Re: Hillsborough County RRF Emission Guidelines Compliance Project
Your letters of November 14 and 19, 1996

The following letter contains the City of Tampa's responses to the Department's request for additional information dated October 14, 1997. The Department's questions are in italics and are followed by the City's responses.

Subject: Confirmation - McKay Bay Waste-to-Energy Report - March 1996

**McKay Bay Plot Plan
Current Layout**

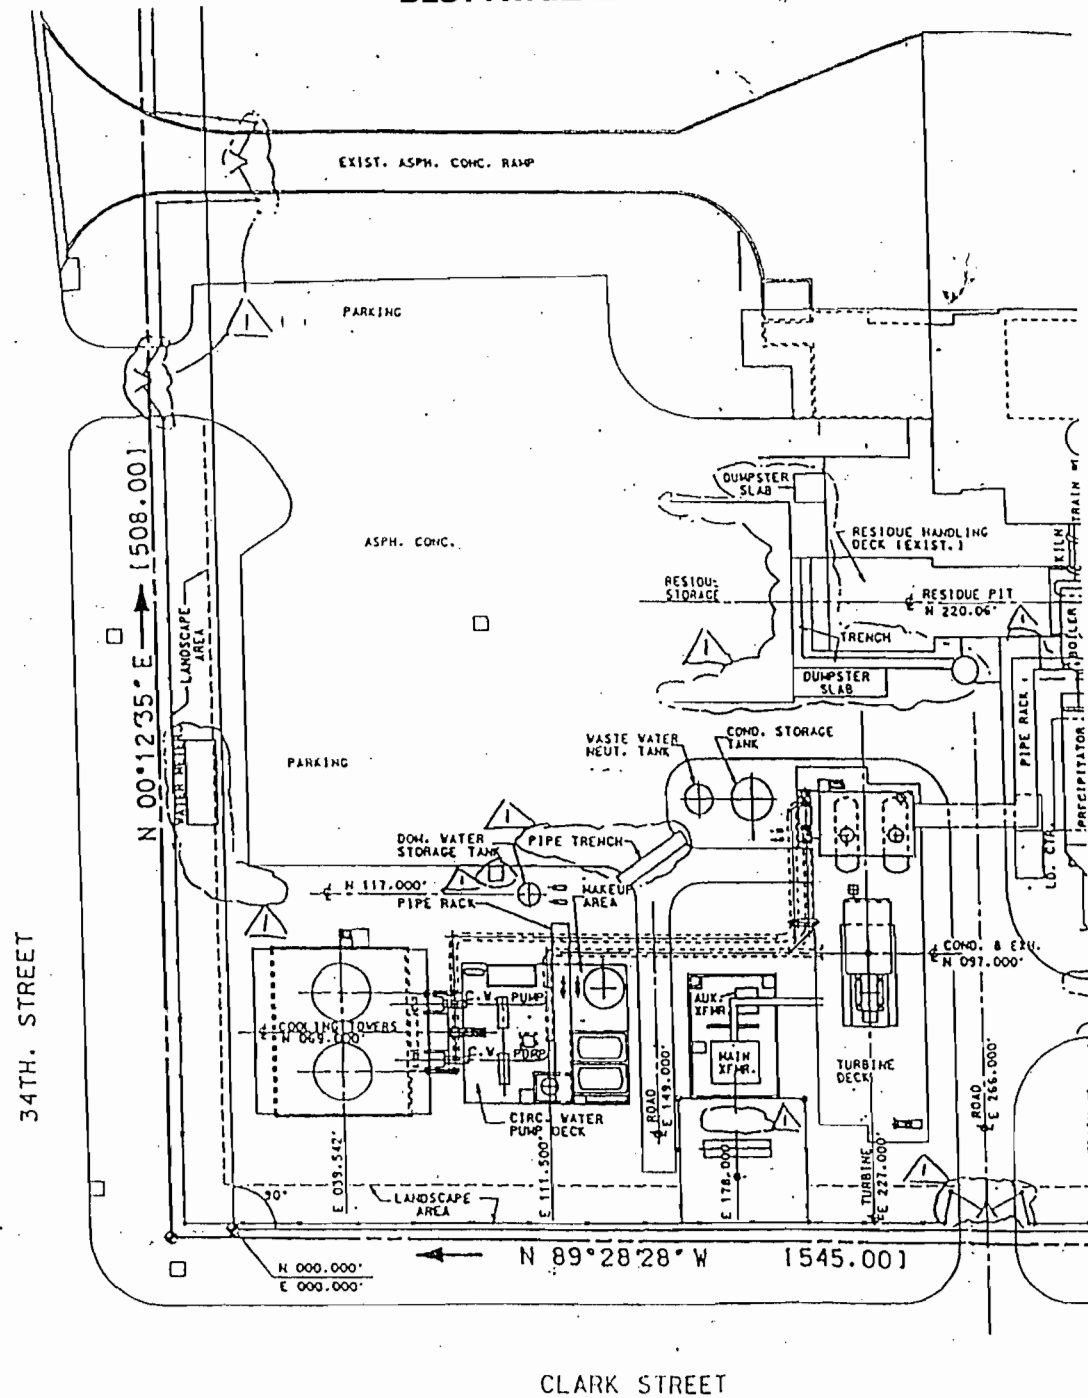
Description: A pre-fabricated metal sided building utilized for maintenance and parts storage is located south of the current stacks (Figure 1).

Description: Current regulations dictate that the ash be stored under roof and chemically treated before disposal off site. Plans are in work for cover to be provided over the existing ash storage area (Figure 1), which is restrictive in size and run off control..

**McKay Bay Plot Plan
Proposed Layout**

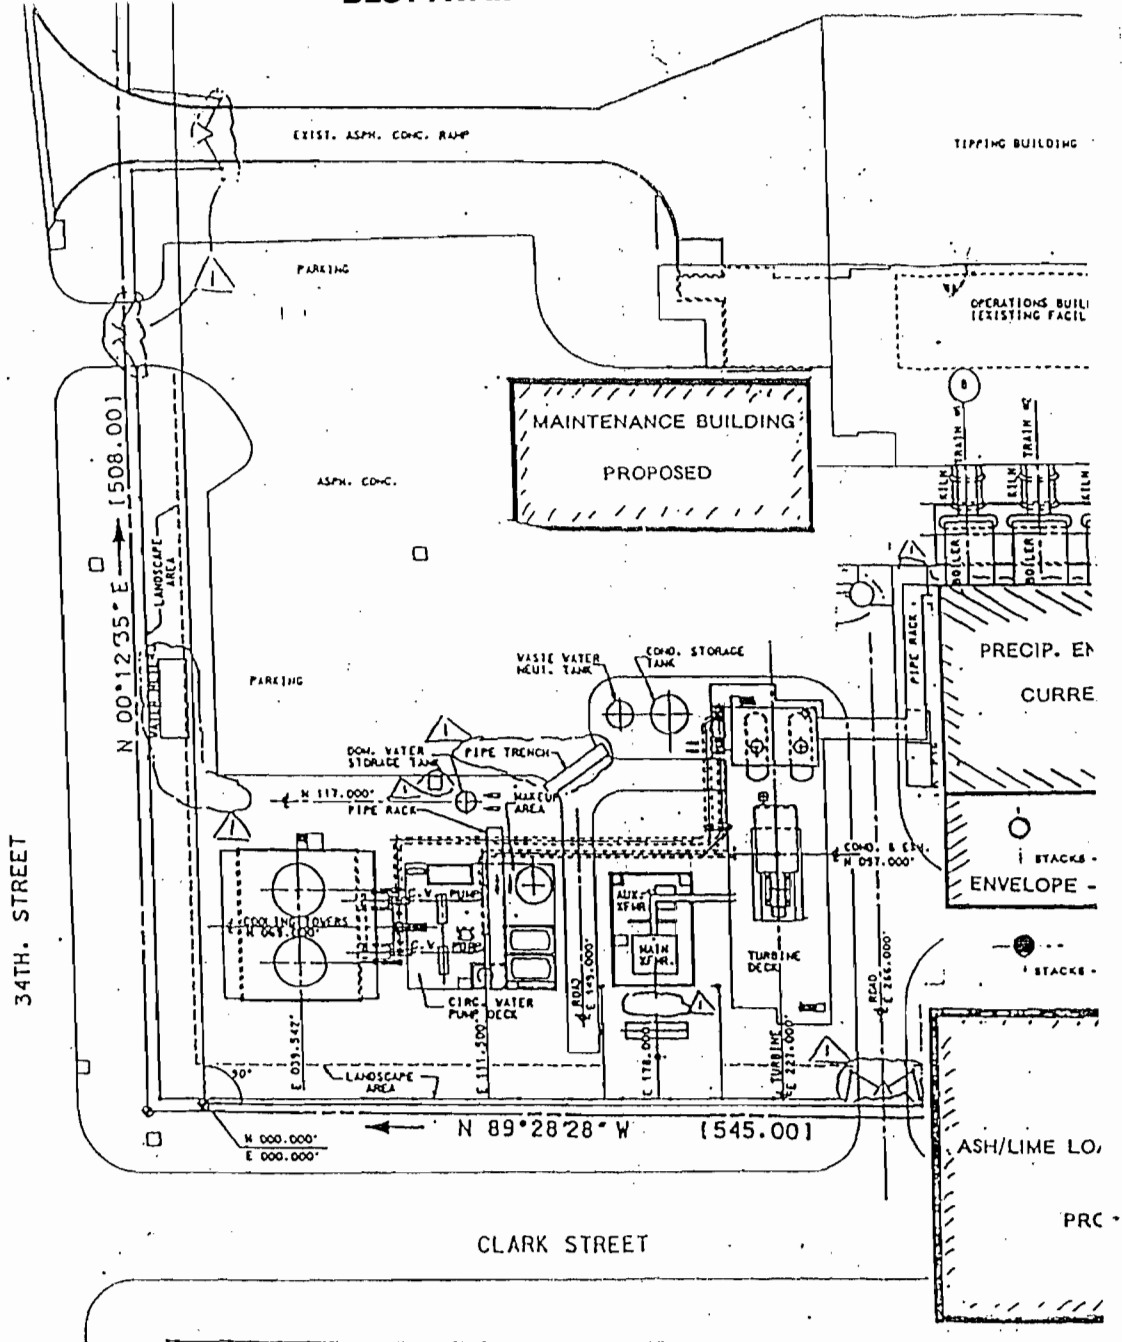
USEPA Compliance Action: Installation of the required scrubber/baghouses will necessitate relocating this building to the area currently used for ash storage (Figure 2).

Figure 3
McKay Bay - Cross Section
Current Configuration

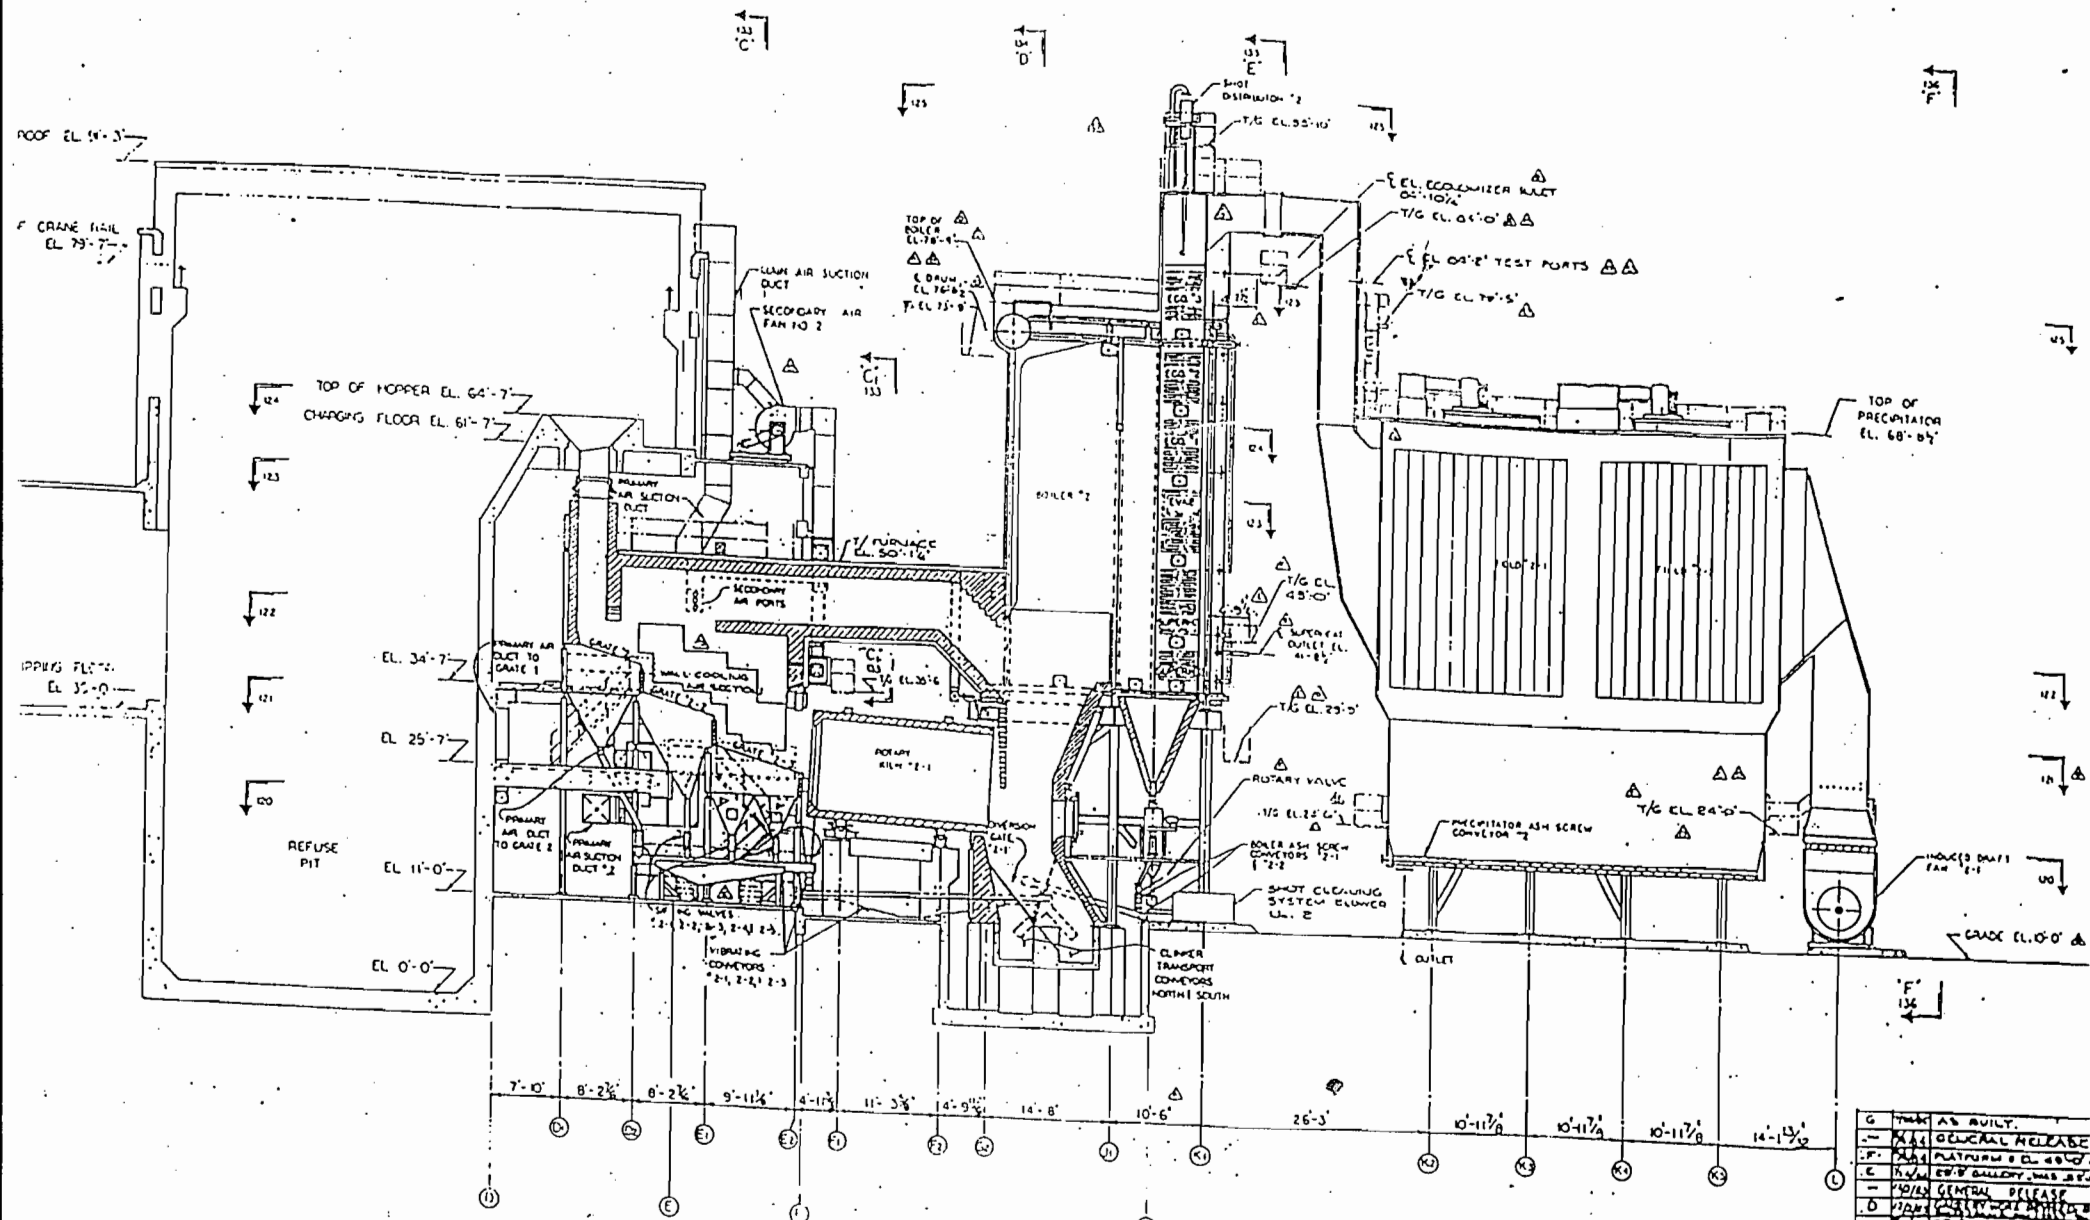
furnace temperature - system pressures - temperatures throughout the total system and steam flow among other parameters. The operators must do this for four lines in addition to monitoring the balance of plant As can be noted from Figure 3, once the burning waste enters the kiln, where approximately 20% of the combustion or final burnout takes place, there is no capability to meter either primary or secondary combustion air and control combustion temperature to inhibit the formation of dioxin.

Figure 4
McKay Bay - Cross Section
Proposed Configuration

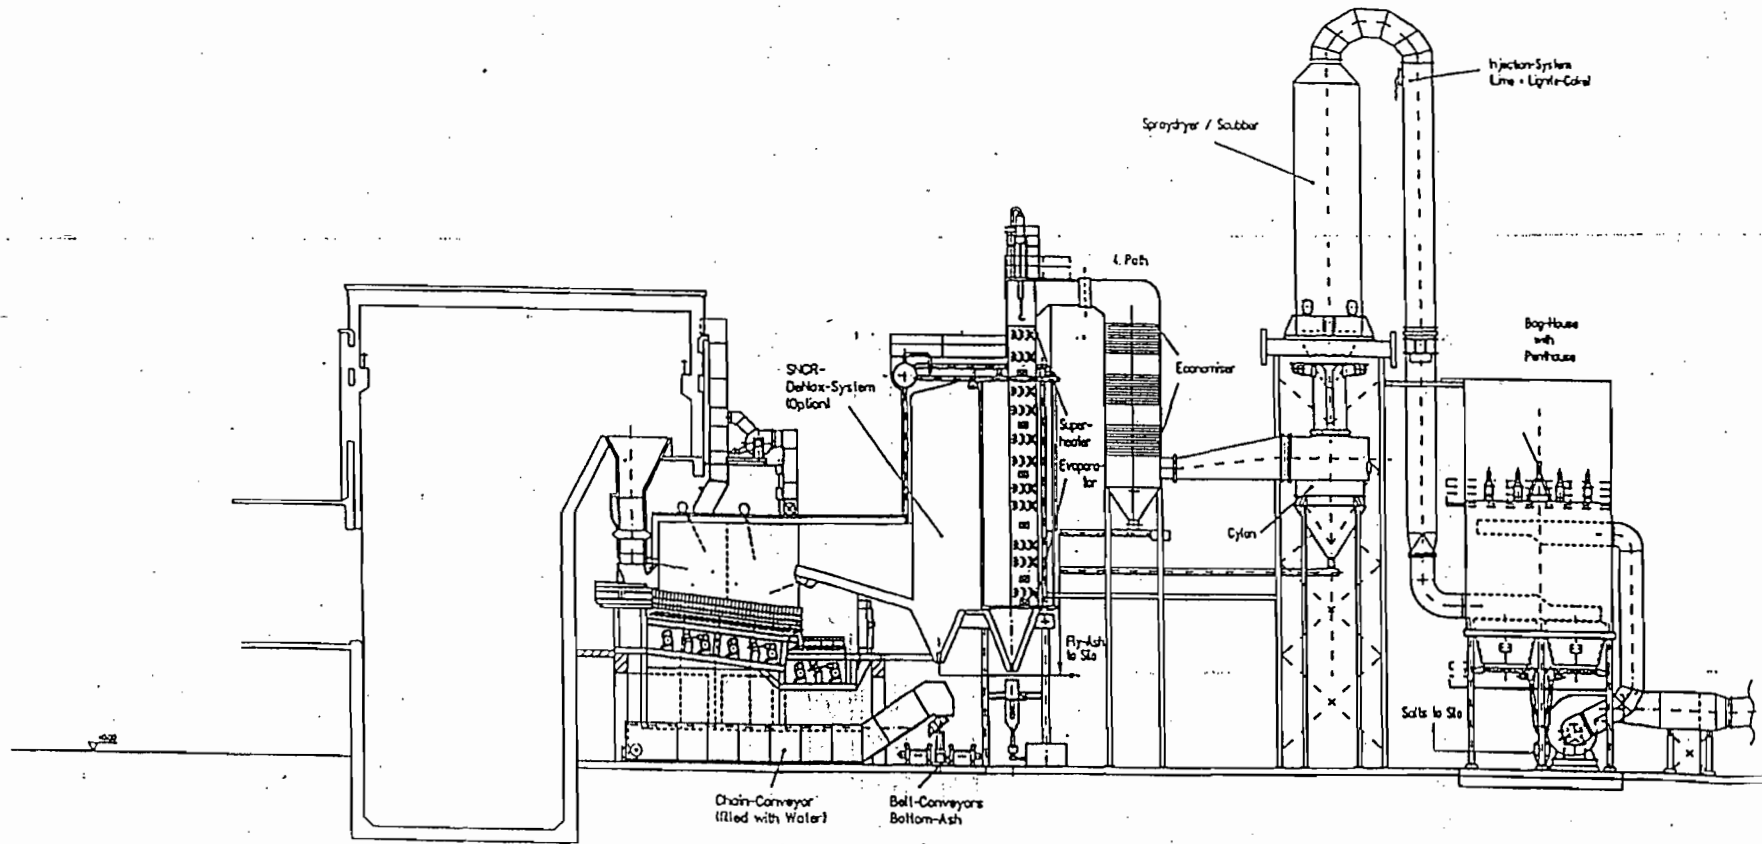
USEPA Compliance Action: The existing system will not comply with the new USEPA Guidelines. It will be modified by reconfiguring the furnace from a grate/kiln system to a grate only system (Figure 4) to permit accurate control of the process and furnace temperatures. The furnace will be refractory or ceramic lined with the flue gas exiting directly into the existing boiler. Waste feed from the existing chute to the three segment reciprocating grate system will be controlled by a hydraulically driven ram. Individual air plenums will be located beneath each grate section and measured air flow controlled by flow control valving in each section. Secondary air is also be similarly controlled for each section . Furnace temperature at each grate section - flue gas temperatures - steam flow - air flows - feed rate - grate speed - and other contributing parameters will be monitored and computer controlled. An individual computer, data acquisition and logging system will be provided for each line.
